Re: RMI Titanium Company Sodium Plant  
Ashtabula County  
OHD 000 - 810 - 242

In response to your letter dated 02 October 1998, here are responses to Ohio EPA's comments on the Groundwater Monitoring Plan for the Closed Landfill (Area A) RMI Titanium Company Sodium Plant, Ashtabula, Ohio (November 1997) prepared on our behalf by Eckenfelder Inc.

**RESPONSES TO COMMENTS FROM OHIO EPA  
DATED OCTOBER 2, 1998  
ON THE GROUNDWATER MONITORING PLAN  
FOR THE CLOSED LANDFILL (AREA A)  
RMI TITANIUM CO. – SODIUM PLANT  
ASHTABULA, OHIO**

FIGURE 1-1  
CROSS-SECTION A-A'

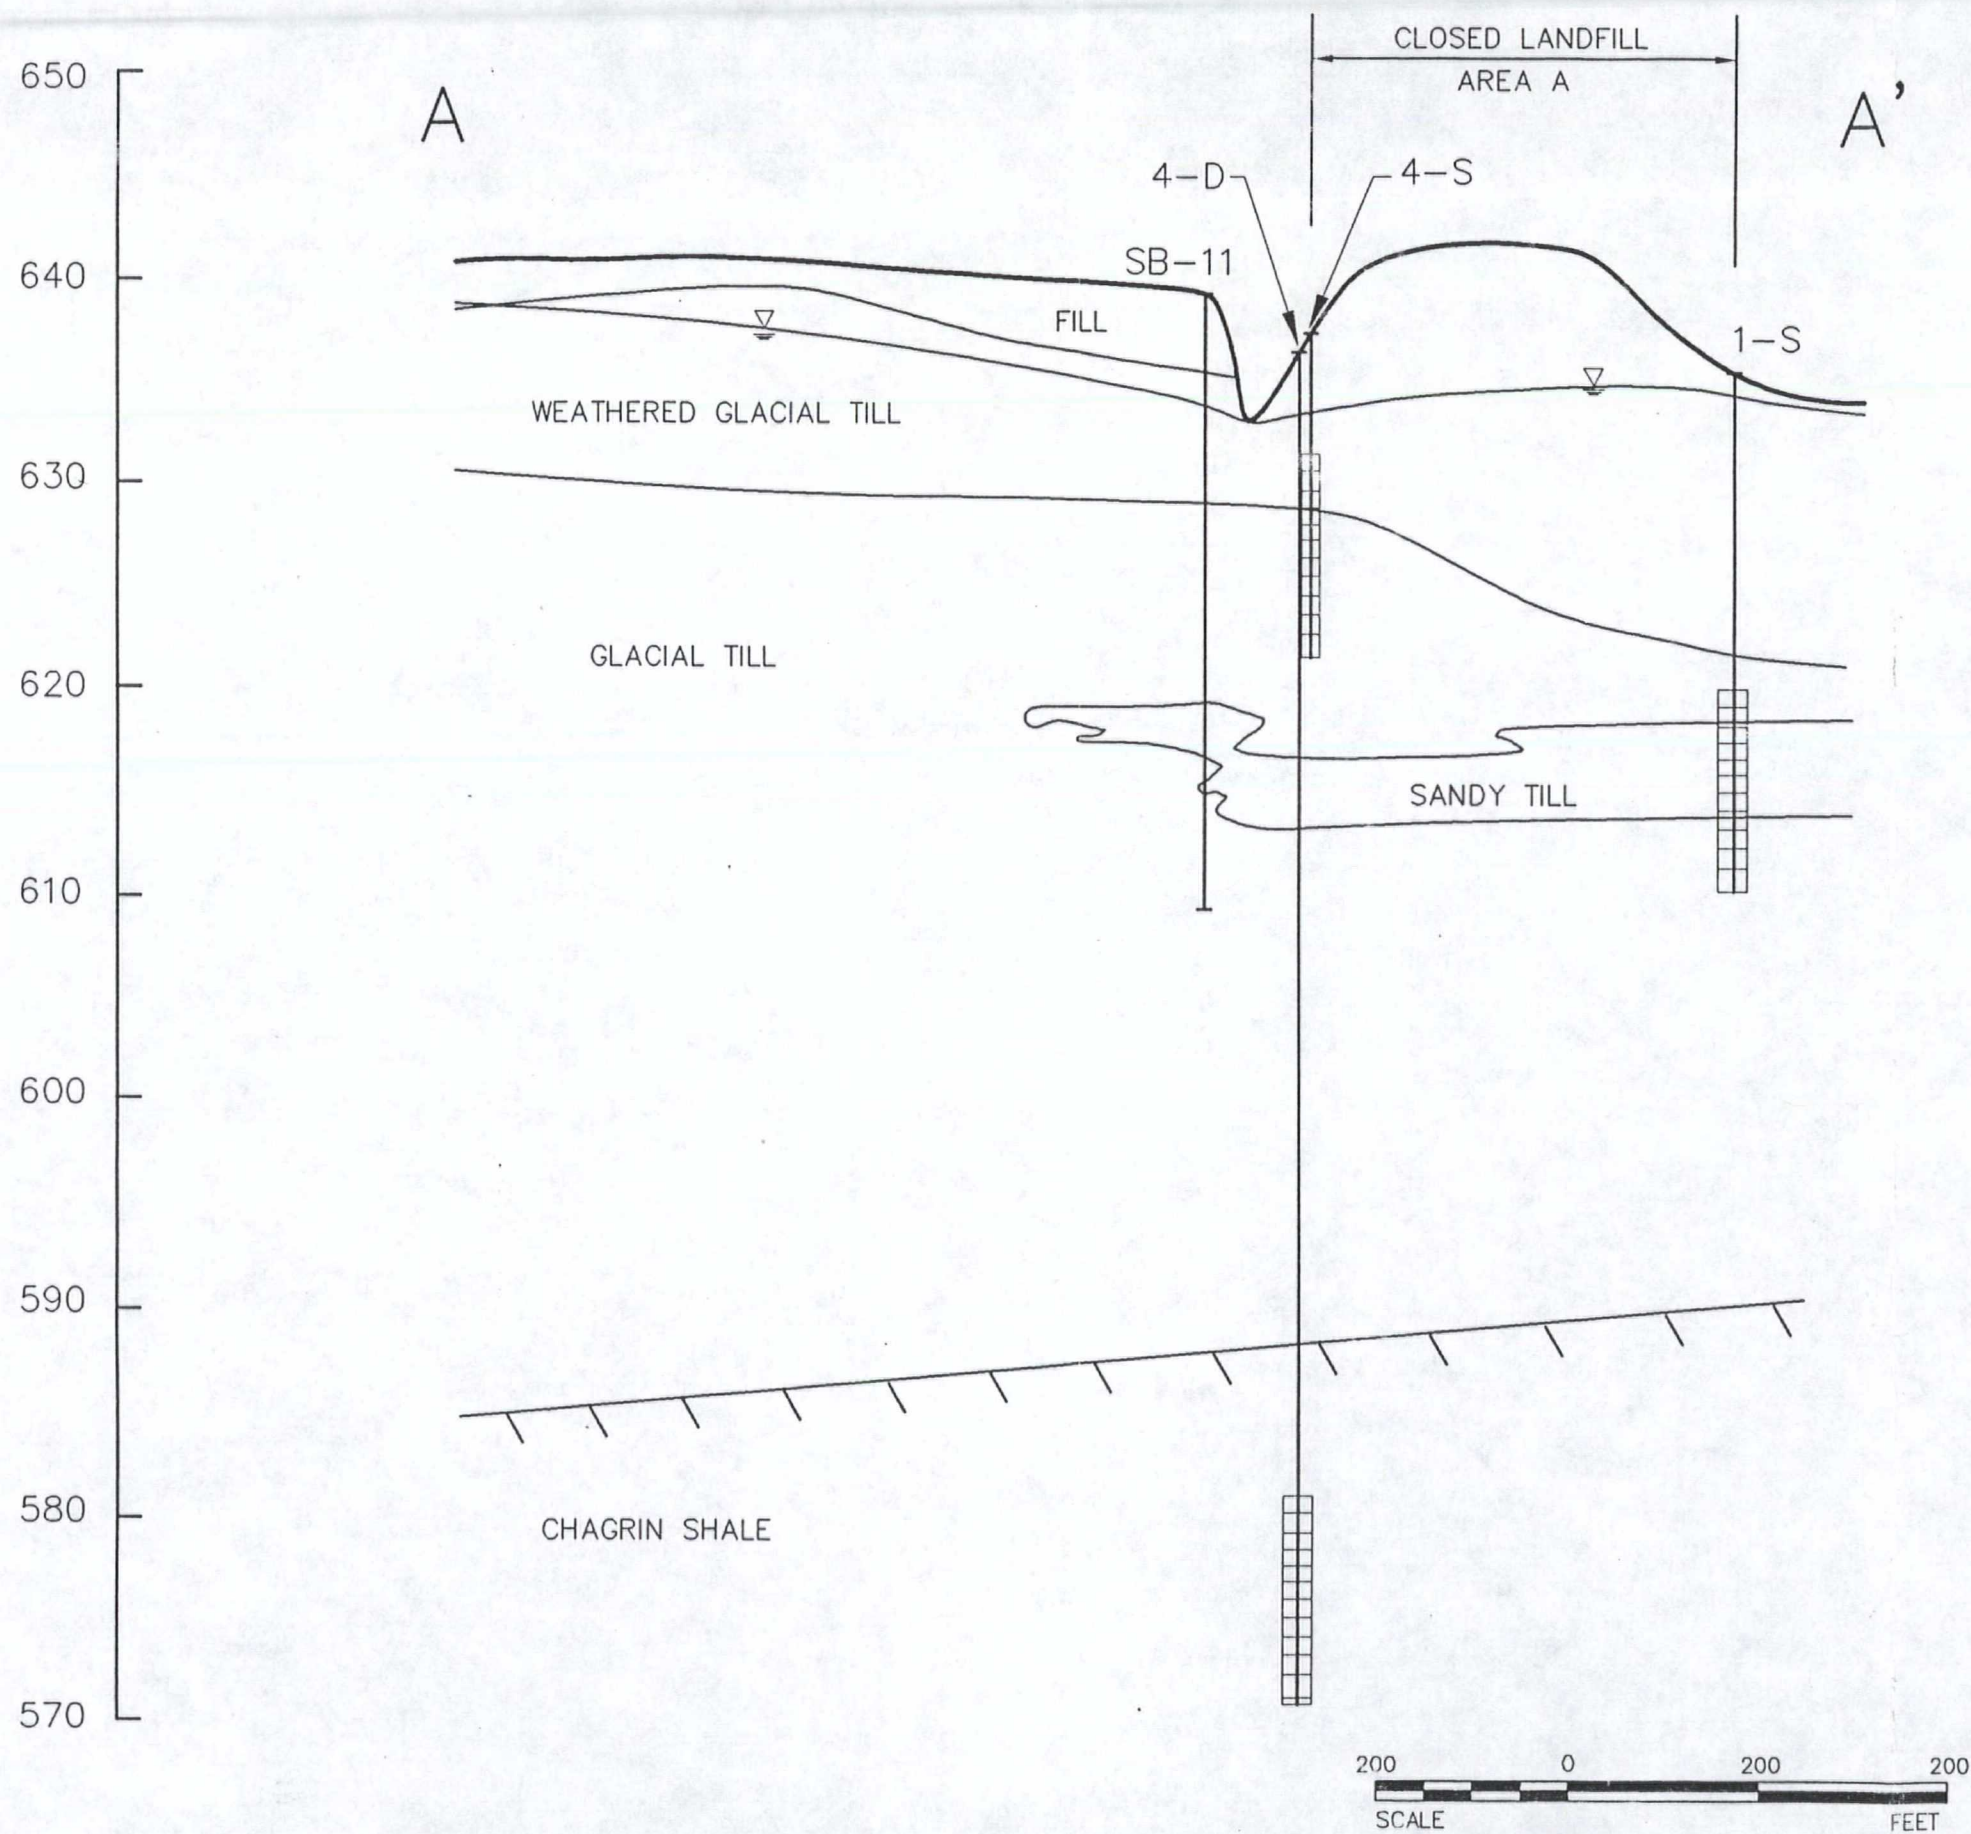
10. The facility did not provide adequate information regarding the stratigraphy of Area A and adjacent areas. Figure 1-1 displays a cross-section AA' that is oriented along an east-west direction and passes through RMI-4S and RMI-1S. The facility should indicate the thickness and position of the clay cap and overlying soils and the contact between the landfill material and unweathered glacial till in this cross-section.

**Response:** The cross-section presented in Figure 1-1 was presented to give a general overview of the landfill in relationship to the underlying water table. Due to the scale of the cross-section the clay cap was not depicted. Based on the available information, the clay cap overlies the top of the landfill and is approximately 2 feet in thickness. A thin soil zone overlies the clay cap in localized areas and is estimated to range in thickness from 2 inches to approximately 2 feet. Soil samples collected during the Shelby tube sampling will provide information regarding the thin soil zone. The objective of the plan is to evaluate groundwater elevation in relationship to the surface seeps, which are estimated to be 4 to 5 feet above the water table. Providing detailed information as to the contact between the landfill material and the unweathered glacial till is not relevant to the objective. Figure 1-1 is sufficient and requires no revision.

FIGURE 1-2  
SHALLOW GROUNDWATER  
CONTOUR MAP

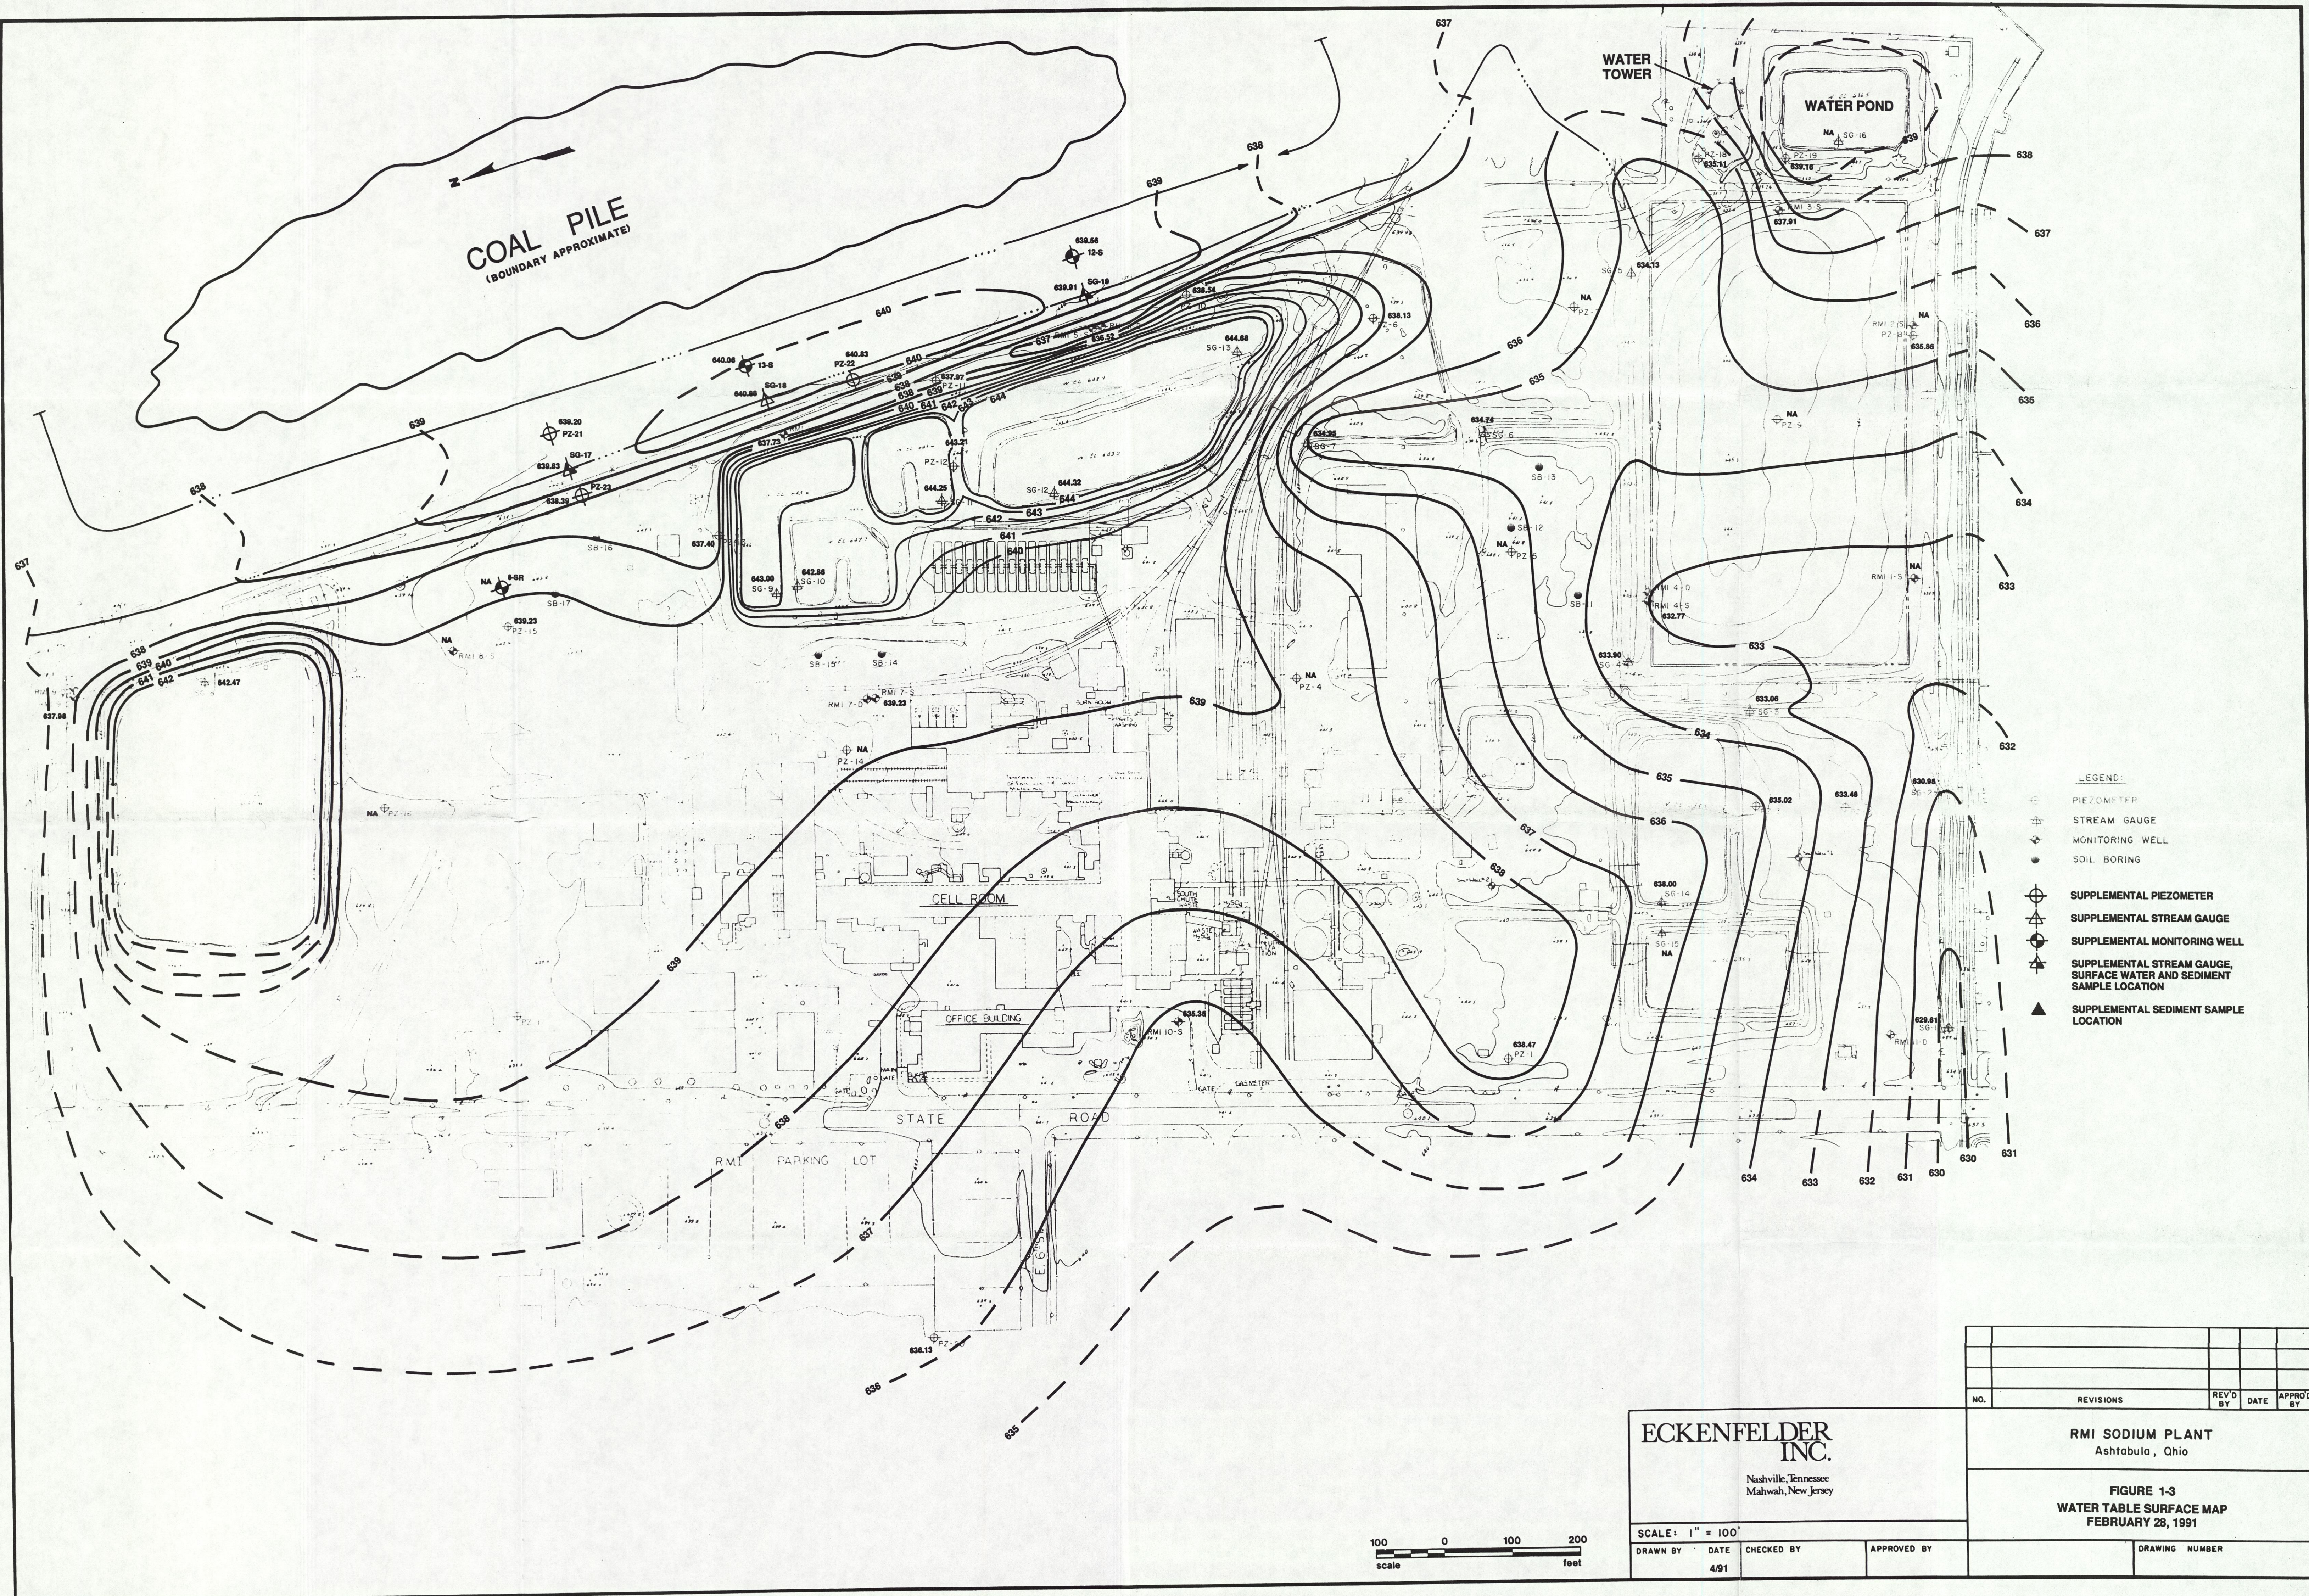
2. The flow directions of shallow ground water at the facility area varies and are apparently controlled by the locations of landfills and by surface topography. Based on the contour maps in Figures 1-2 and 1-3, shallow ground water in Area A flows approximately to the southwest. RMI-3S appears to be located in the upgradient direction. PZ-1, PZ-2, PZ-3, PZ-5, PZ-4, and RMI-4S are progressively located in the downgradient direction.

**Response: Groundwater flow within the water table zone is influenced primarily by discharge to the surface water drainage features, which border the landfill. The surface water pond has been removed and the leaky pipes associated with the water tower have been repaired. Therefore, the previous resulting recharge will no longer influence groundwater flow directions in this area. The locations of the wells and piezometers are positioned to appropriately characterize the water table beneath the landfill.**
